Access Compliance Report

Public Rights-of-Way

(Curb Ramps)

Intersection ID: 20522	Main Street: CALUMET_PL	Cross Street: MONTPELIER_RD	Location: NW
ADA ID: DB1D3FA936DA	Ramp Type: PerpDiag	Initial Pass/Fail: Fail	Overall Compliance: No
Severity Score: 10			
Codes/Mitigation Info/Possible Solution		Field Measurements/Component Compliance

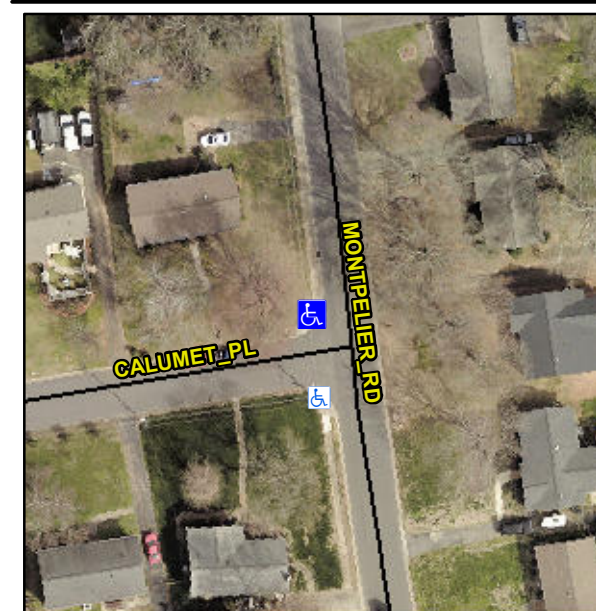
Not Found, R304.5.1, R304.5.3

Compliance	Description	Data	Compliance	Description	Data
N/A	Ramp Length (in)	60.0	Yes	Ramp Slope (%)	5.8
No	Ramp Width (in)	47.0	No	Ramp XSlope (%)	5.0
N/A	Flare Type LT	N/A	N/A	Flare Type RT	N/A
N/A	Flare Slope LT (%)	N/A	N/A	Flare Slope RT (%)	N/A
N/A	Flare Traversable LT?	N/A	N/A	Flare Traversable RT?	N/A
N/A	Landing Length (in)	N/A	N/A	DWS Provided?	N/A
N/A	Landing Width (in)	N/A	N/A	DWS Contrast?	N/A
N/A	Landing Slope (%)	N/A	N/A	DWS Length (in)	N/A
N/A	Landing X Slope (%)	N/A	N/A	DWS Full Width?	N/A
N/A	Landing Curb? (Y/N)	N/A	N/A	DWS Offset (in)	N/A
N/A	Shared Landing?	N/A			
N/A	Gutter Ponding?	N/A	N/A	Gutter Slope (%)	N/A
N/A	Gutter Lip Ht (in)	N/A	N/A	Gutter X Slope (%)	N/A
N/A	Painted X Walk1?	No	N/A	Painted X Walk2?	No
	X Walk 1 Direction	To S		X Walk 2 Direction	To E
N/A	X Walk 1 Width (in)	N/A	N/A	X Walk 2 Width (in)	N/A
	X Walk 1 Slope (%)	0.9		X Walk 2 Slope (%)	5.5
	X Walk 1 X Slope (%)	3.9		X Walk 2 X Slope (%)	1.8

Remove & Replace Curb Ramp With Two New Directional Ramps or Equivalent.
